IMPORTANT PARTS-SERVICE COMMUNICATION

NO: CAG-450

SUBJECT: BBC**A2C Incorrect Wiring

Figure 1

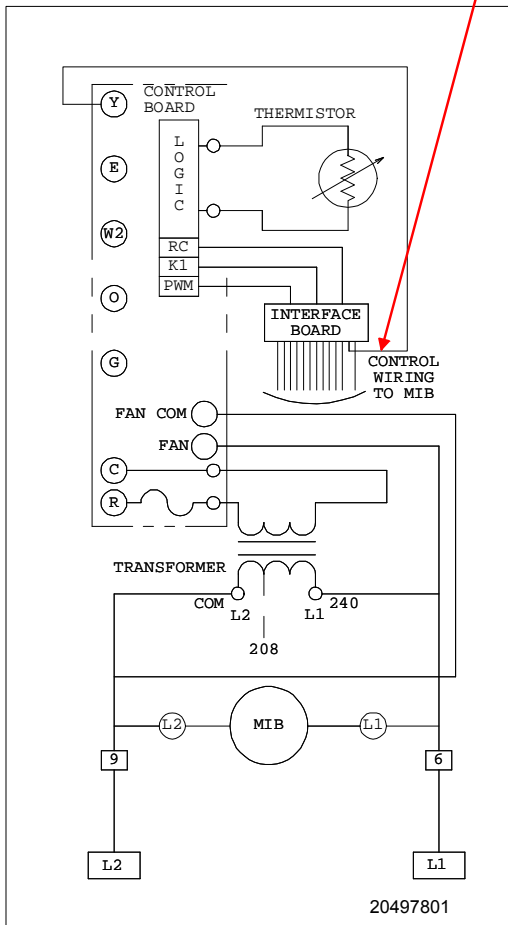
While reviewing the current issue it was discovered that there are discrepancies between the ladder-wiring diagram, and the wiring schematic located in the blower compartment (refer to fig.1). The ladder-wiring diagram illustrates the white #2 wire going from “Y” terminal to Interface Control Board; this is incorrect. The wiring schematic illustrates the white #2 wire going from MIB to “Y” this is correct. During inspection process please use a white correction fluid, and make appropriate corrections (refer to fig.2).

Incorrect Ladder Diagram
(Please white this area out)

Figure 2

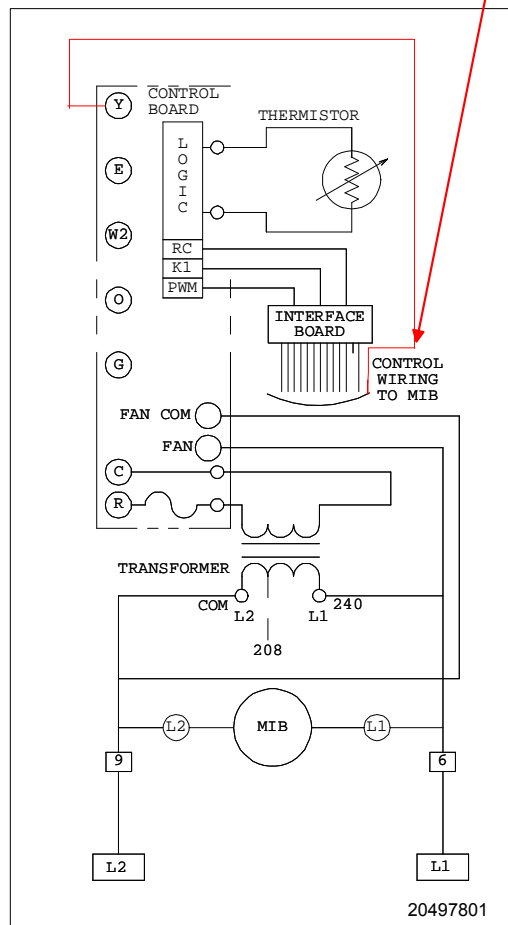
Correct Ladder Diagram
